PG&E Letter DCL-08-094

Response to Request for Additional Information Regarding Supplemental Response to Generic Letter 2004-02, "Potential Impact of Debris Blockage on Emergency Recirculation During Design Basis Accidents at Pressurized Water Reactors"

**RESPONSE TO NRC REQUEST FOR ADDITIONAL INFORMATION REGARDING  
SUPPLEMENTAL RESPONSE TO GENERIC LETTER (GL) 2004-02, "POTENTIAL  
IMPACT OF DEBRIS BLOCKAGE ON EMERGENCY RECIRCULATION DURING  
DESIGN BASIS ACCIDENTS AT PRESSURIZED WATER REACTORS"**

**Figure 2 – Tray No. 3, Horizontal, Covered with Kaowool Board, Pre-Test**

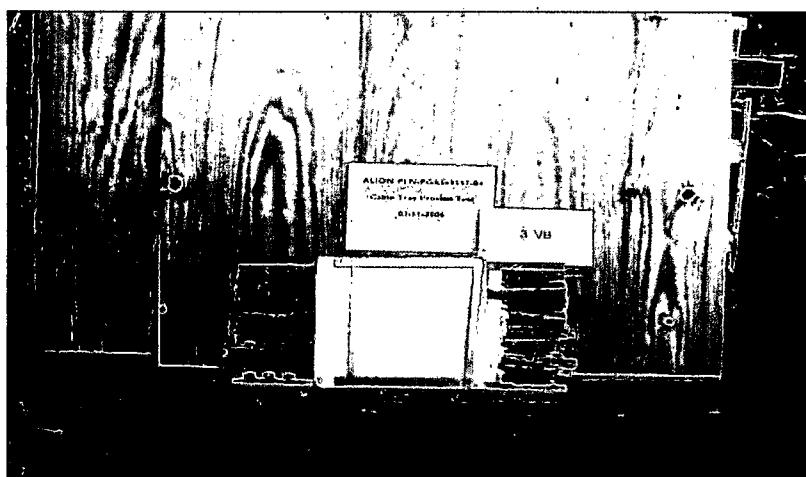
*Please state whether the fire stops and unjacketed debris in containment outside the crane wall would be exposed to the runoff of spray drainage streams, and state whether this effect was accounted for in the erosion testing that was performed on these materials (as opposed to assuming that all spray flow was in the form of fine droplets).*

The cable tray specimens were fabricated from 12-inch wide standard stock material. The trays were filled with an assortment of cables, numbered and sized to achieve a nominal fill of approximately 16 percent. This cable fill ratio maximizes the amount of fire stop material and bounds the majority of the cable trays. Fire stops were fabricated with foam and fibrous damming material (Kaowool board and Kaowool blanket). The fire stops were installed into the cable trays per existing plant details and drawings. The cover material for the covered cable tray specimens was either sheet metal or Kaowool board as per existing design details. As shown by Figures 2 and 3, the cable tray cover was conservatively sized to just cover the width of the fire stop leaving a portion of the damming material exposed to the tested spray water, whereas an actual cable tray cover would cover the entire length of the tray.

The erosion testing for the horizontal cable tray fire stops is conservative in that the covered fire stop specimen conservatively exposes the ends of the fire stop material to the erosion of the containment spray whereas the installed configuration has the fire stop completely covered. Also, the uncovered fire stop specimens were tested with direct spray; whereas the installed uncovered fire stops are afforded protection from the containment spray by the cable trays installed above. In both of these configurations, covered or uncovered cable trays, the fire stops would not be exposed to runoff or spray drainage streams as they are protected by the cable tray cover or the cable tray above.

Figure 1 – Test Tank Showing Agitators

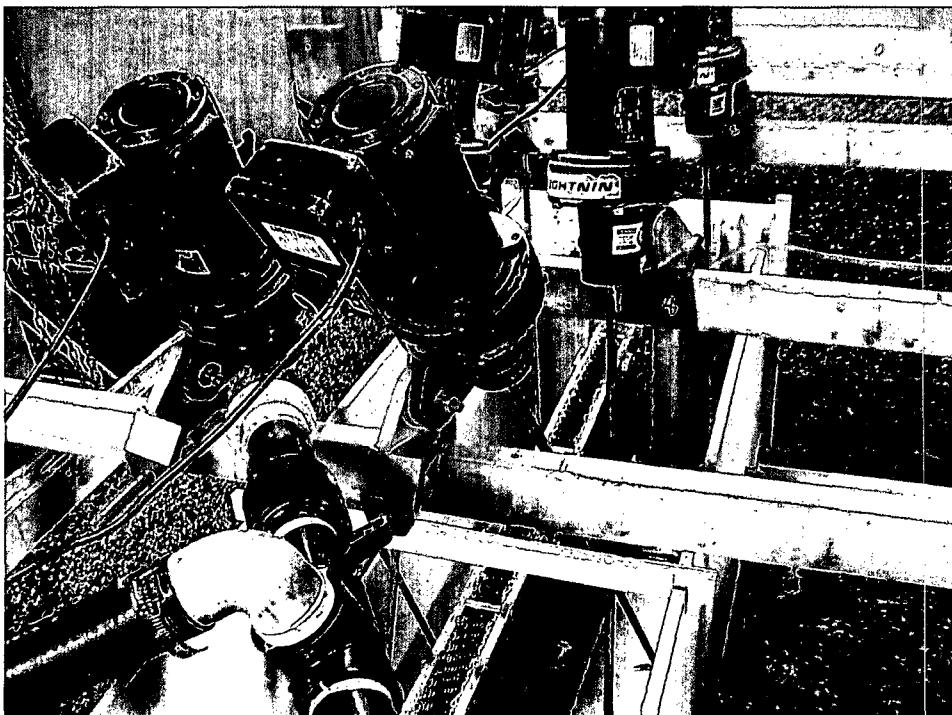
*Please provide an evaluation that shows that the stirring in the tank to prevent debris settling did not affect the formation of the strainer debris bed in a non-prototypical or non-conservative manner (prevention or wash away of debris beds, or disturbance of the debris bed by non-prototypical intrusion of paint chips or large pieces of fiber).*

A total of six motor driven agitators were used for each sector head loss test. The agitators were placed as follows (see Figure 1):

- 2 agitators vertically down, one on each side of the plenum
- 2 agitators crossed at approximately 60 degrees down on each side of the sector test article. The propellers on these 4 agitators were approximately 6 inches from the floor of the test tank.

The strainer is located approximately 1 inch above the floor of the test tank. The agitators ensure a uniform mixing, producing a homogeneous debris mix in the tank fluid. The agitators develop a relatively gentle circular eddy current with no preferential direction of the material. During the sector head loss testing it was observed that the paint chips would randomly circulate throughout the test tank; thus, the debris was not forced in any direction.

**Figure 1 - Test 14-S-PSG, and 15-S-PSG Head Loss Testing Results**

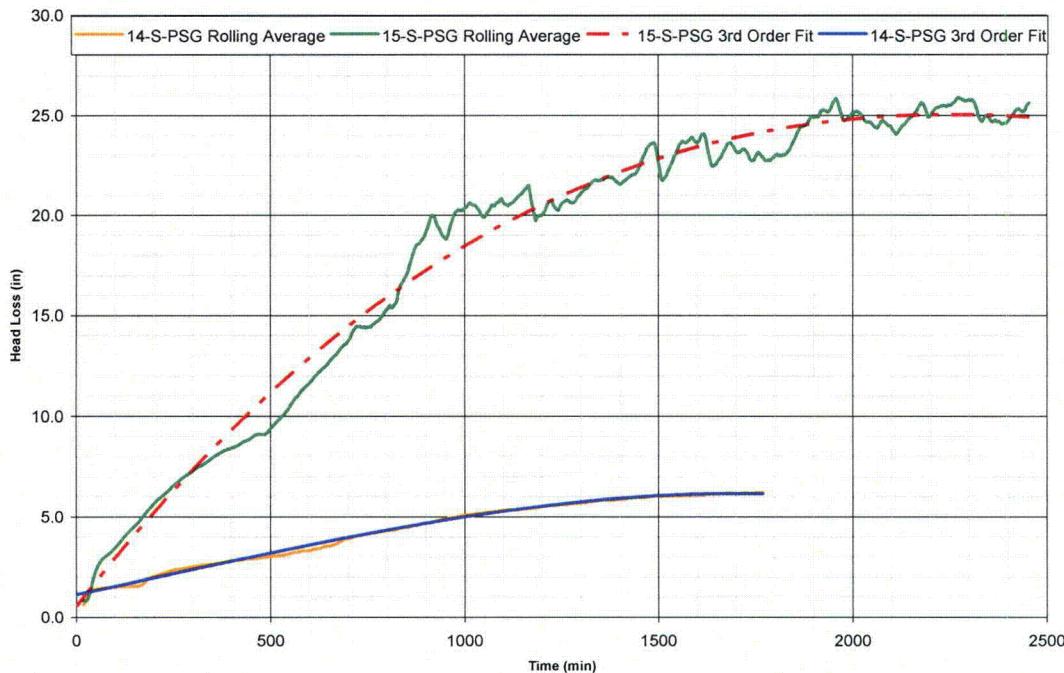
*Please provide a basis for not performing a time-based extrapolation of the test data out to the emergency core cooling system (ECCS) mission time. [The staff understands that the integrated chemical head loss test was run for the number of fluid turnovers that would occur in the plant. However, there are potential time-based debris bed change mechanisms that could result in additional head loss (e.g., compaction). It has been observed in testing, after many test rig fluid volume turnovers, that after particulate debris has been filtered from the water the strainer head loss continues to increase with time.]*

DCPP's head loss tests are continued for at least 24 hours after the last addition of chemicals. The amount of fiber debris has been limited based upon the extensive debris mitigation efforts. After this limited amount of fiber and/or paint chip debris has formed a debris bed (less than 100 percent coverage of the screens), a portion of the chemical and particulate debris will adhere to the fiber and/or paint chip bed and essentially block this portion of the screen area. Where there is open screen area the remaining chemical and particulate debris would pass through the screen without causing additional head loss. The resulting head loss observed is due to the flow across the limited open screen area. The turbidity of the test flume did not decrease after the debris bed was saturated with all of the chemical and particulate debris that it could absorb and the remaining chemical and particulate debris continued to be recirculated through the open screen area. At that time there is no further increase in head loss; in fact, a slight decrease in head loss was observed during some of the tests. Any extrapolation of data at the test termination point would be expected to essentially be a straight, flat line (see Figure 1).

Figure 1 - Cold Leg Recirculation Flow Path

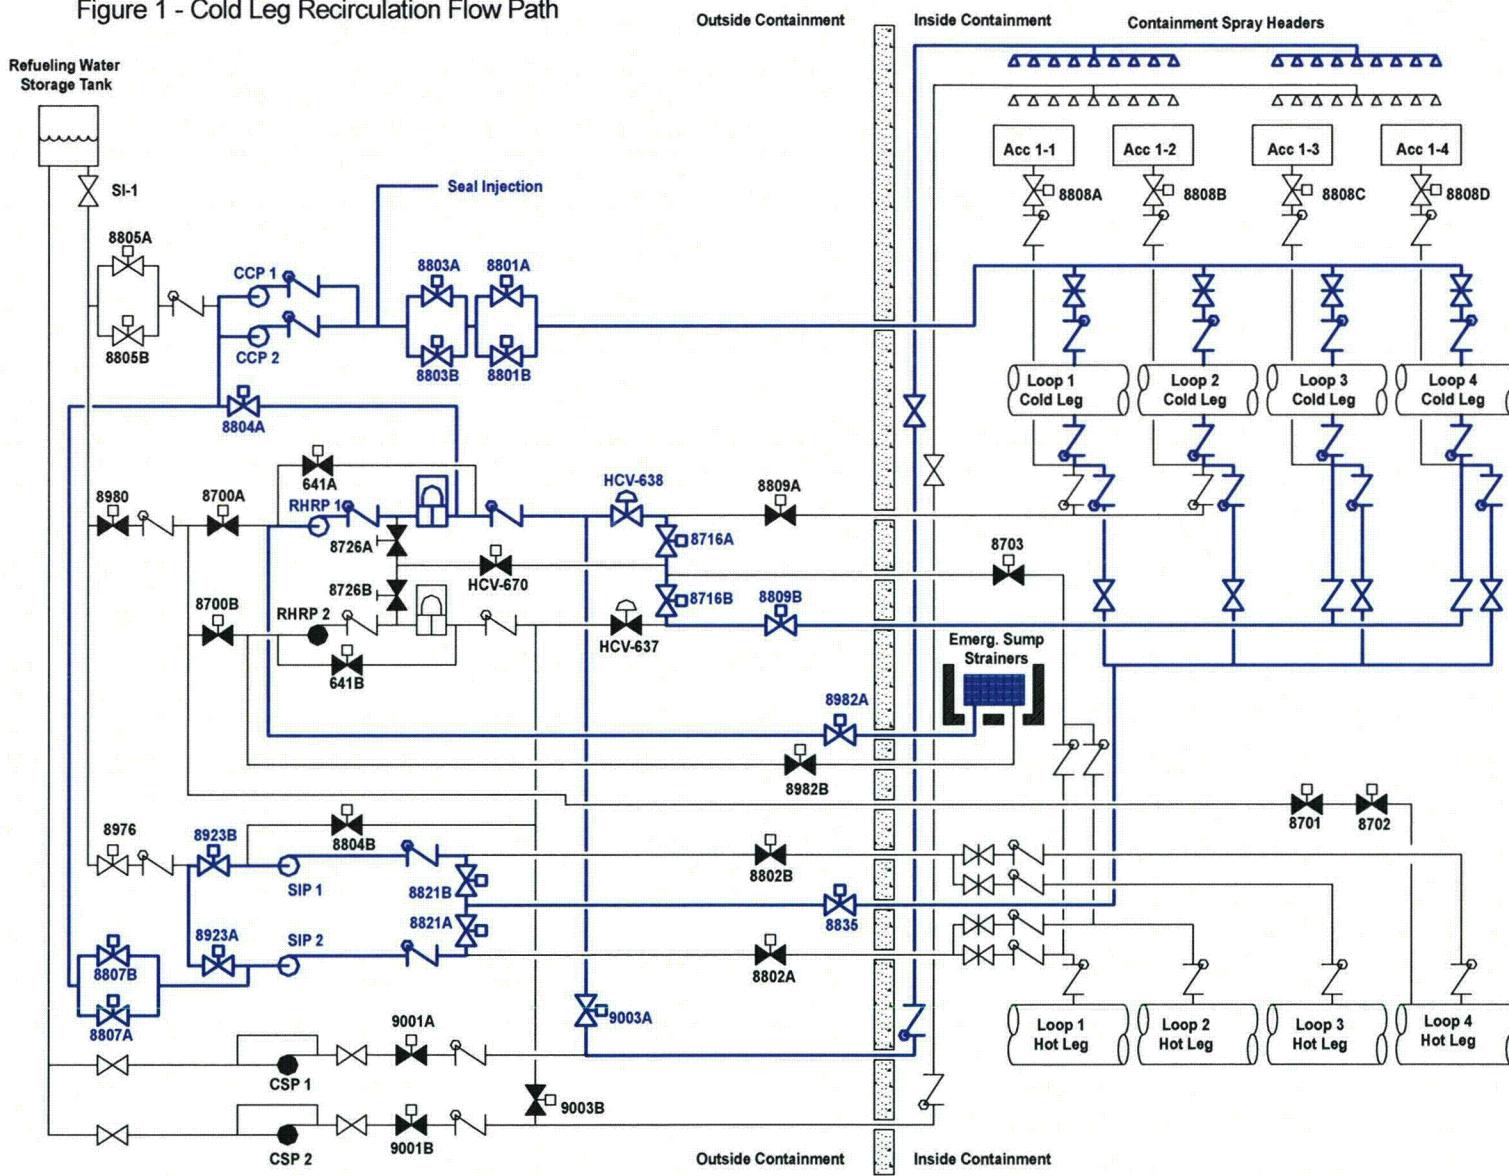
*Please provide justification for the computed limiting ECCS flow rate being “worst case flow conditions.” Please Include a description of the methodology used to determine the maximum flow rate (e.g., runout flow from the vendor pump curve, a calculation using a standard hydraulics code, etc.), as well as a description of the assumptions and the assumed system and component configuration that provides the conservative maximum flow rate (e.g., for single pump operation, can flow cross over to downstream piping in the non-operating train?).*

The flow alignments analyzed are shown in Figures 1 and 2. These figures correspond to the single pump cold-leg and hot-leg recirculation cases reported in the response to Question 12.
